Additions: ***bold italic***  
Deletions: ~~strikethrough~~  
Commentary: ***bold italic***

Figure 98-7 in "ABILITY DETECT",  
link is down, no link codewords  
with good CRC, so no-one is on  
the far end

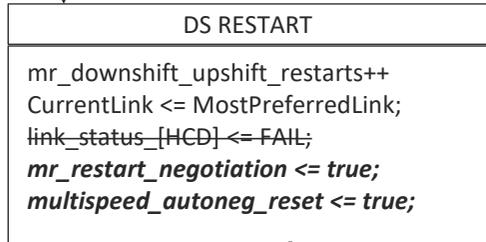
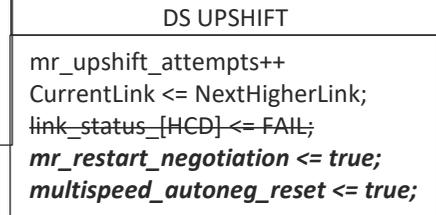
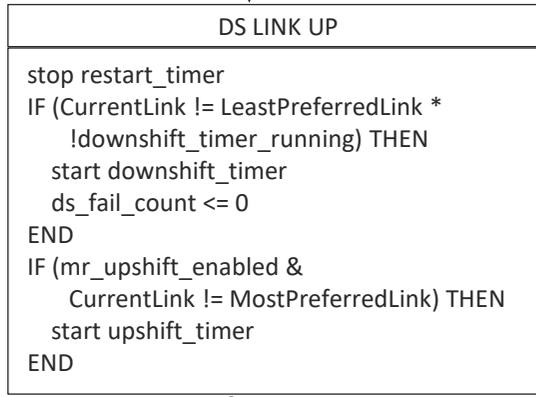
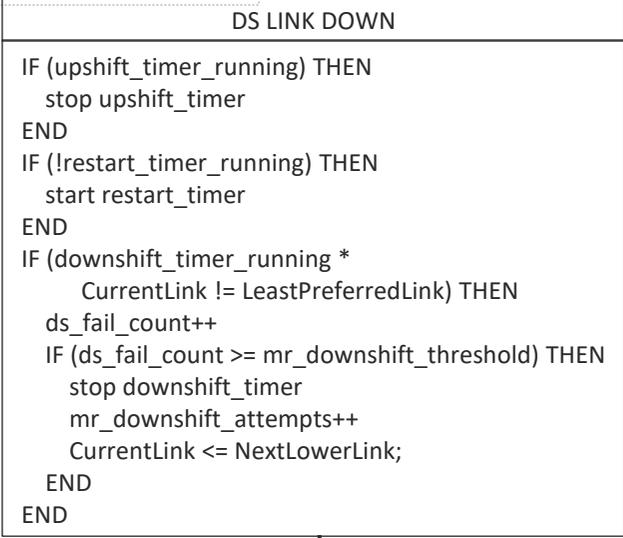
*!mr\_autoneg\_enable +  
!mr\_downshift\_enabled*

*mr\_autoneg\_enable = TRUE +  
mr\_downshift\_enabled = TRUE*

At least one of autoneg or downshift are  
disabled

Both autoneg and downshift are  
enabled

*mr\_autoneg\_enable \*  
mr\_downshift\_enabled*

transmit disable true transition

link status ok transition

upshift timer done transition

restart timer done transition \*  
ability\_match=false

Restart Figure 98-7  
(Arbitration state  
diagram ) and Figure 98-  
11(AN speed selection)
